**RESOLUTION ON REQUEST FROM CASEY'S MARKETING COMPANY (LESSEE)
TO AMEND THE EXISTING PLANDSM: CREATING OUR TOMORROW PLAN
FUTURE LAND USE DESIGNATION FOR PROPERTY LOCATED AT 3200 AND 3212
SOUTHWEST 9TH STREET AND 930 PARK AVENUE**

Communication from the City Plan and Zoning Commission advising that at their December 19, 2019 meeting, the following action was taken regarding a request from Casey's Marketing Company (lessee) represented by Marni Beck (officer) to rezone property located at 3200 and 3212 Southwest 9th Street from "C-1" Neighborhood Retail Commercial District and "R1-60" One-Family Low-Density Residential District to "PUD" Planned Unit Development. This will allow for redevelopment of the existing 21,664-square foot general food sales store with a 4,817-square foot gas station/convenience store to include sales of wine and beer and a pump island canopy with 14 fueling locations. The subject property is owned by Tursi, LC.

CONCEPTUAL PLAN CASEY'S GENERAL STORE

4 Pump Island Canopy - (Street Side)
18'-0" x 1'-0"

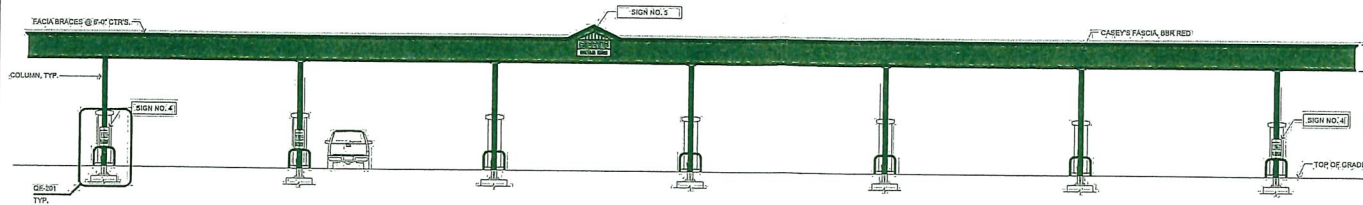
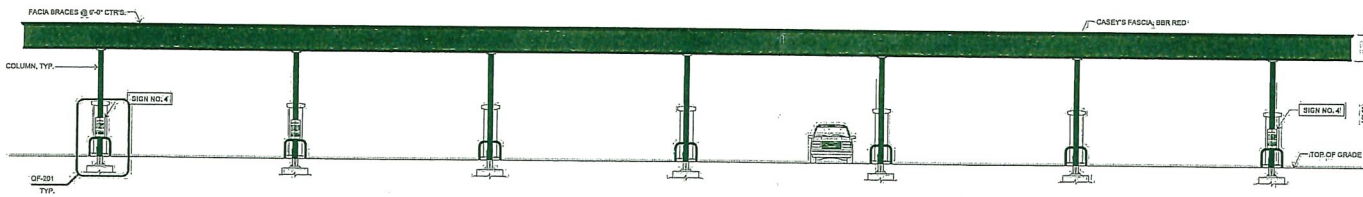
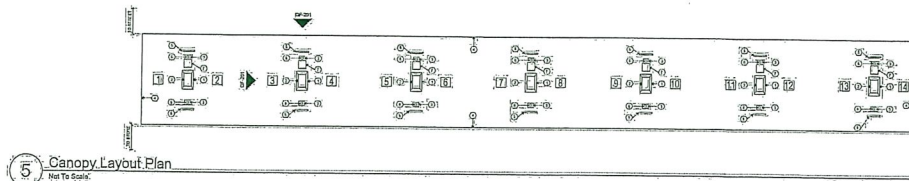
The proposed fuel pump island canopy would be sided with metal and supported by metal columns. Staff believes that these should be clad with brick to match the building. There needs to be an articulation in the canopy to break up the long linear pump array that is proposed. Staff recommends a canopy design similar to the Casey's Store at 63rd Street and Grand Avenue. The applicant is in the process of submitting a revised canopy concept that would be similar to that location in terms of the articulation but would also provide the brick wrapped columns.

The previously submitted information indicates the total canopy height would be approximately 20 feet 7-inches. The height of the underside of the canopy would 16.5 feet. In this location the site is relatively flat. Therefore, staff believes these maximum heights can be stepped down to meet this standard and still provide enough flexibility for grades. The applicant is submitting a revised design with a center articulation that would exceed the maximum height. However, the overall height of the remaining portion of the canopy should be kept under the 18 foot maximum.

1. Reduction of the canopy height for the major portion of the canopy to 18 feet maximum. This would exclude any articulation feature that is designed to break up the expanse of the canopy length.

2. Provision of at least one articulation in the canopy to break the long expanse and cladding of the support columns in brick to match the building, to the satisfaction of the Planning Administrator.

Monument Sign (4 Product)								
Sign #	Type	Location	Illumination	Dimensions		Height	Area Ft²	
				Bottom	Top			Width
6	House Logo	Freestanding	Street	Internal	7'3"	13'0"	7'7-1/2"	86.3
7	Price Sign	Freestanding	Street	Internal	1'9"	7'3"	7'7-1/2"	41.94
							Total	78.24

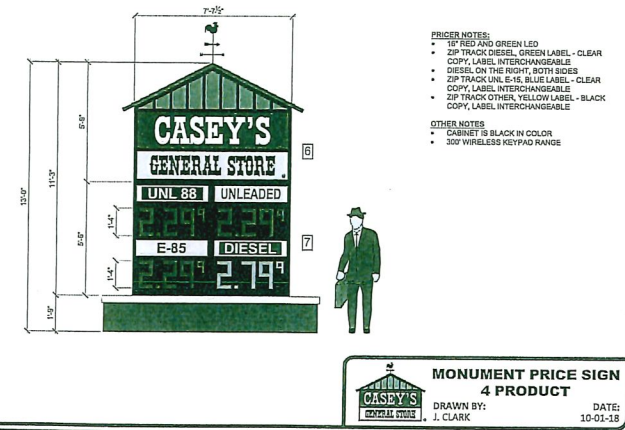
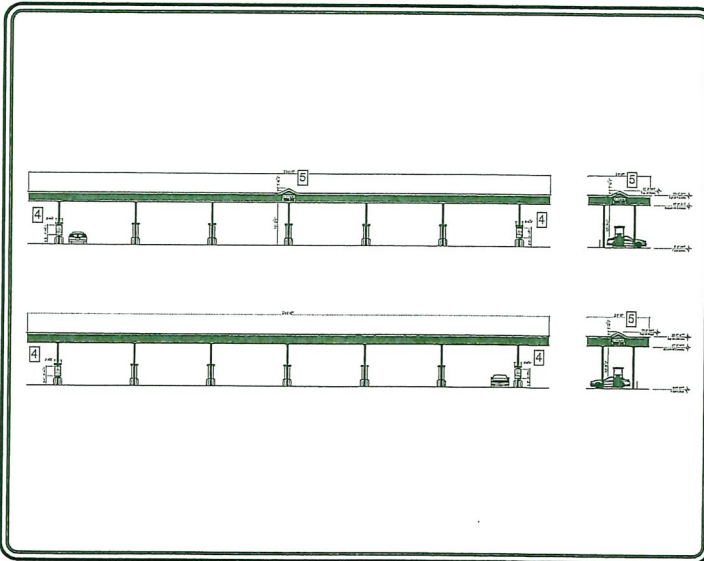
The submitted Conceptual Plan includes a monument style sign. The sign would be 13 feet tall with a 1-foot 9-inch tall brick base. The City has adopted the "FSO" Freestanding Sign Overlay District and amended the monument sign design requirements. Below are the relevant portions of Section 134-1276 and Section 134-3 of the Zoning Ordinance.

Staff believes the proposed monument signs should comply with these standards including the provision of a solid opaque base, constructed of brick, stone, concrete block or other durable material that is no less than 2 feet tall or 25% of the total height whichever is greater.

3. Revision of the proposed monument sign to comply with the “FSO” Freestanding Signs Overlay District provisions.
4. Addition of a note indicating that existing overhead electrical utility service lines will be placed underground as part of any PUD Development Plan.
